## LETTER OF TRANSMITTAL

**PROJECT:** RENOVATIONS TO BUILDINGS S & V  
ST. JOHNS RIVER STATE COLLEGE, ORANGE PARK CAMPUS

**JOB NO.:** 015J03

Attached please find Addendum No. 2 for the above referenced project. Distribution is as follows:

<b>ESK</b> <b>0.1-1</b>	PROJECT TITLE: RENOVATION TO BUILDINGS S & V, ST. JOHN'S RIVER STATE COLLEGE	
	SHEET TITLE: SYMBOL LEGEND, FIXTURE SCHEDULE	
	DRAWN BY: LYW	CHECKED BY: RCC
	DATE: 11/21/11	2 ADDENDUM #2

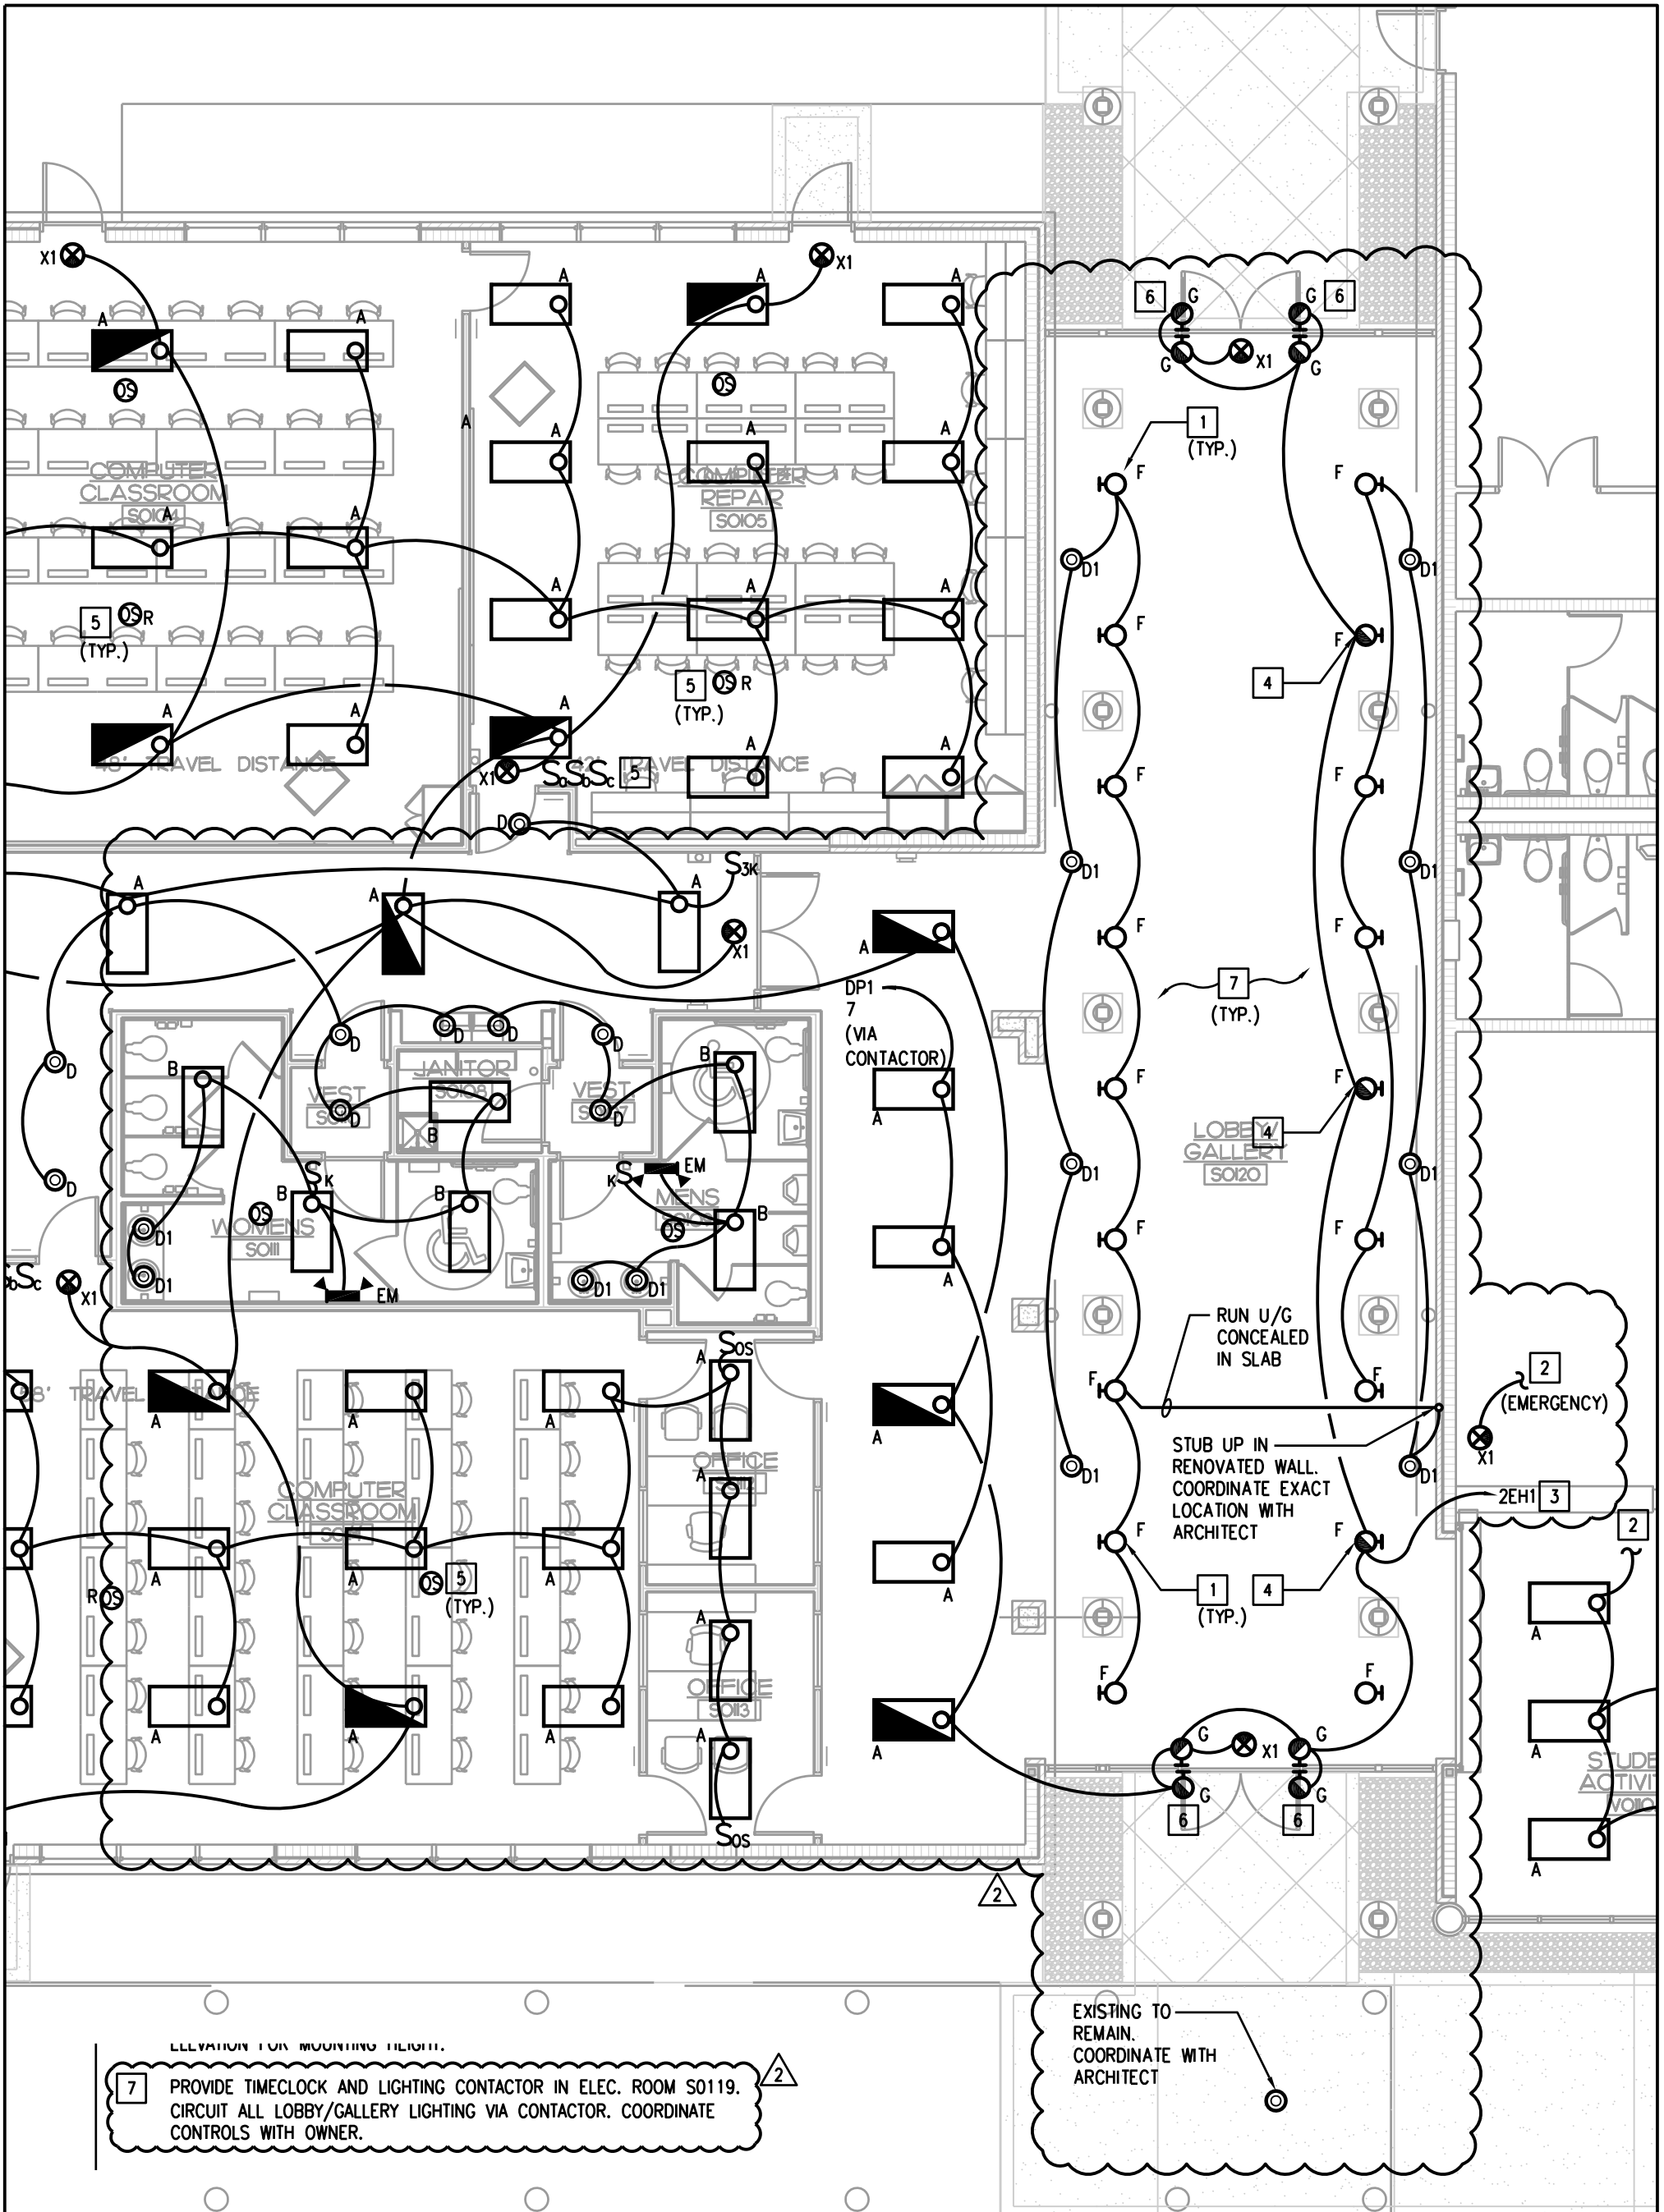
1. Refer to attached supplemental drawing ESK0.1-1: Added fixture types "D1" and "EM" to fixture schedule. Revised lamp wattage of fixture type "F".
2. Refer to attached supplemental drawing ESK1.1-1: Revised lighting quantity and locations to match Architectural RCP. Revised emergency circuiting. Added type "D1" downlights in restrooms. Added timeclock/lighting contactor for lobby area. Added exit sign in Building "V".

SHEET TITLE:  
BUILDING "S" RENOVATION PLAN LIGHTING

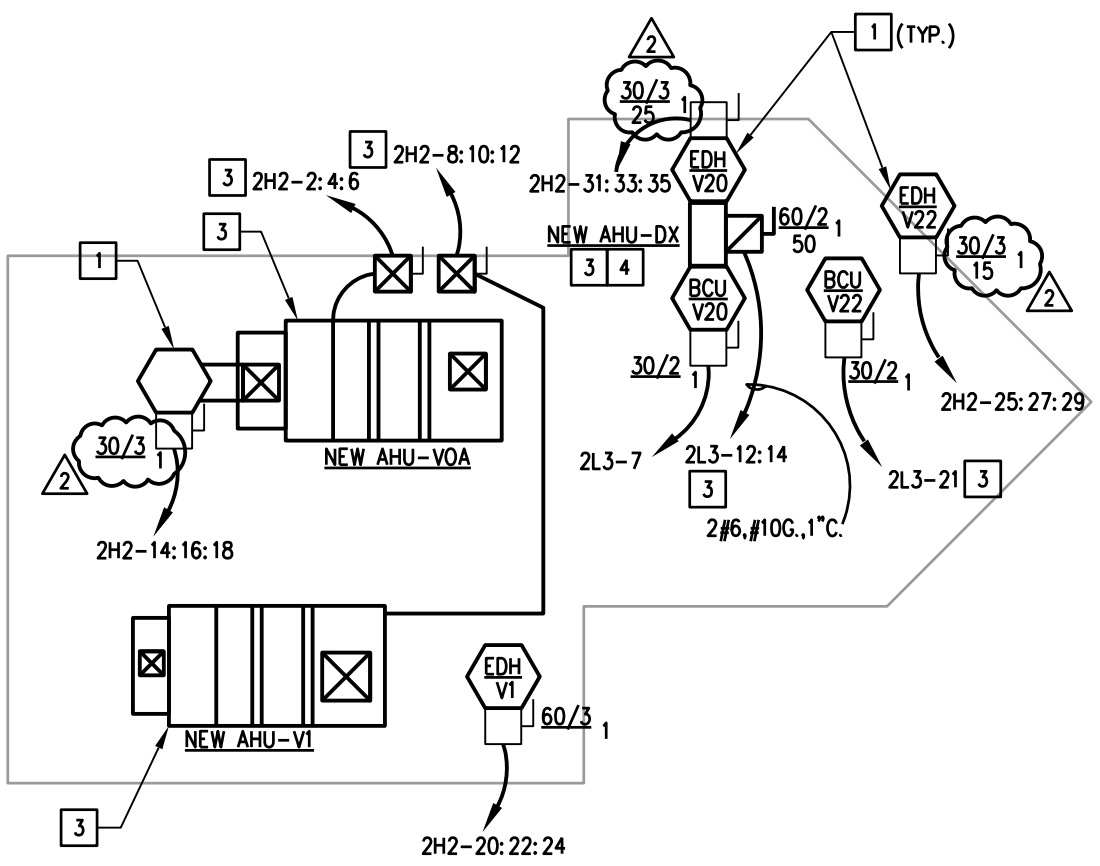
7 PROVIDE TIMECLOCK AND LIGHTING CONTACTOR IN ELEC. ROOM S0119. CIRCUIT ALL LOBBY/GALLERY LIGHTING VIA CONTACTOR. COORDINATE CONTROLS WITH OWNER.

ESK  
 4.1-1

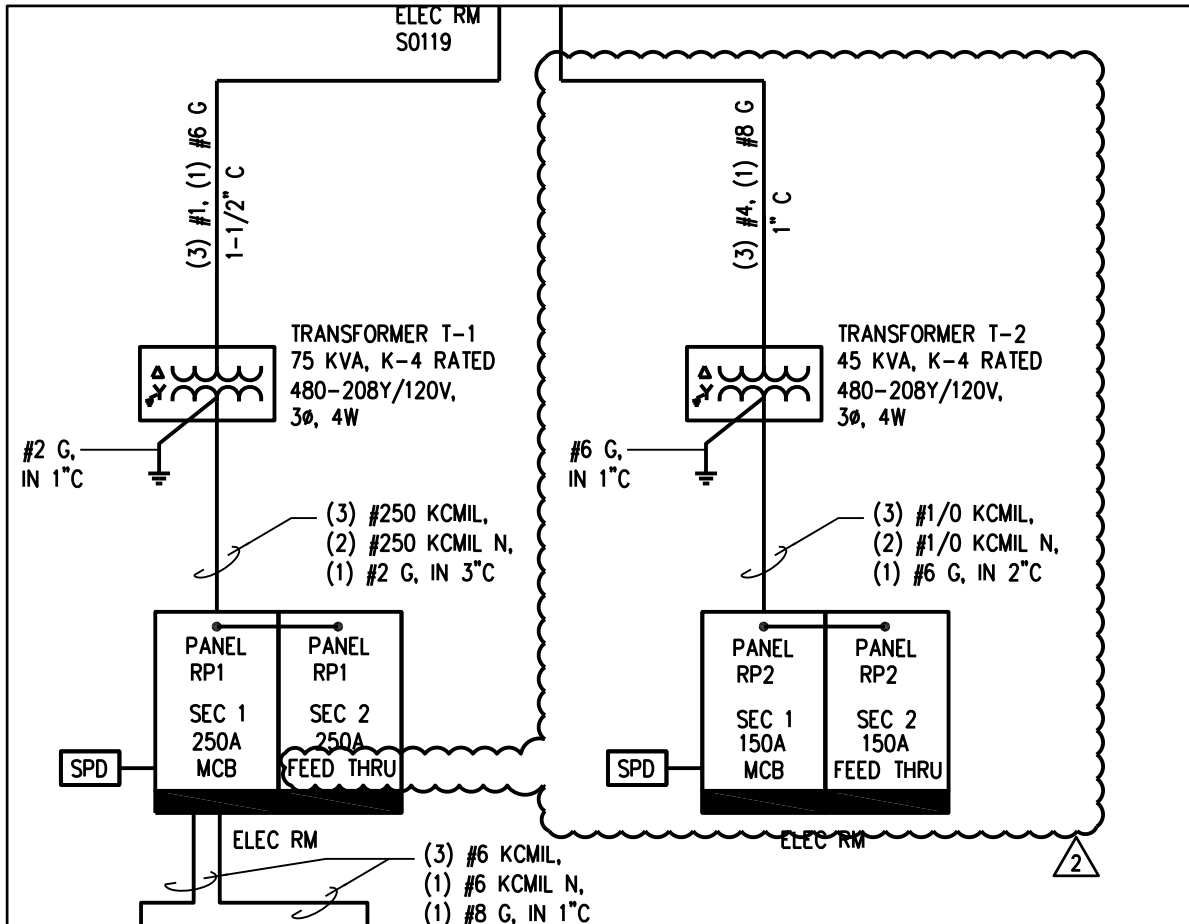
5. Refer to attached supplemental drawing ESK4.1-1: Revised Panel "2H2" electric duct heater loads and breakers to match HVAC revisions.
6. Refer to attached supplemental drawing ESK5.0-1: Revised Transformer T-2 to 45kVA. Revise Transformer primary, secondary feeder, and ground sizes accordingly. Revise Panel RP-1 and Panel RP-2 Section 2 to read "FEED THRU".
